Issue date: April 28, 2003  
Revision 1

SIL No. 642

## CR105X auxiliary contact failure

**Figure 1**

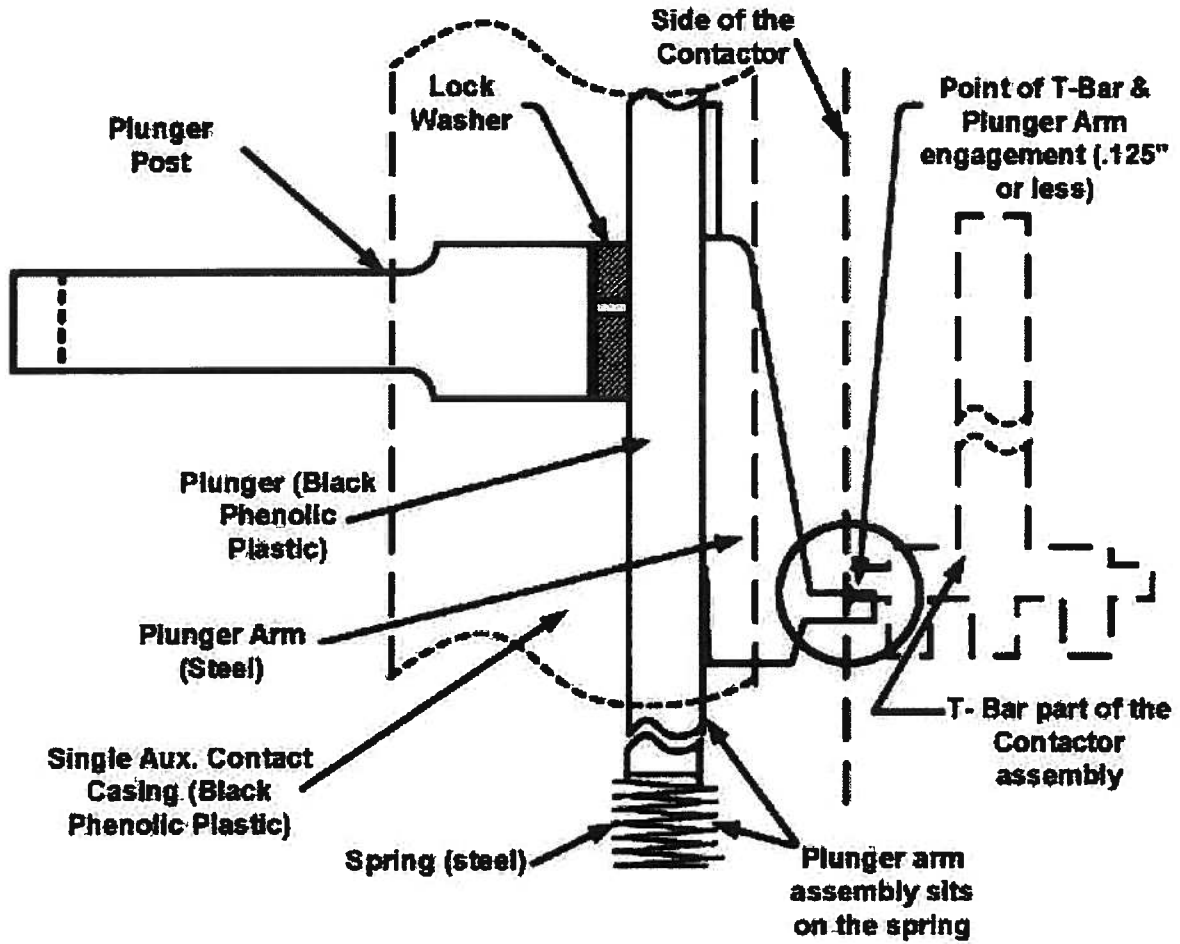
Recently at a BWR in the United States, a GE CR105X auxiliary contact failed to change state from the open to closed position. Plant troubleshooting revealed that the CR105X auxiliary contact was stuck in the open position. During repair, the auxiliary contact plunger arm was found disengaged from the T-Bar (see [Figure 1](#)), which caused the failure of the contact to change state. The cause of the disengaged plunger arm and loose plunger post was determined to be a missing #6 lock washer.

CR105X auxiliary contactors have been sold as either kits ([Figures 2 and 3](#)), or as part of an assembly. The CR105X auxiliary contacts sold as kits contain the #6 lock washer; however, the provided installation instructions did not contain guidance on where to install the #6 lock washer or the required torque to the plunger post. Assemblies shipped from the factory containing an auxiliary contact may not have the #6 lock washer installed. The plunger arm may disengage from the T-Bar causing the failure of the contact to change state if the plunger post is not properly torqued or if the #6 lock washer is not installed. There should be no gap between the steel plunger post and phenolic plunger (see [Figure 1](#)).

1. Visually verify that the #6 lock washer is installed between the plunger post and the plunger. There should be no gap between them.
2. If the #6 lock washer is missing, either install a new #6 lock washer or replace the auxiliary contact with a new one containing a #6 lock washer.
3. If the plunger arm is determined to be loose, tighten the plunger post to 4-7 in-lbs.
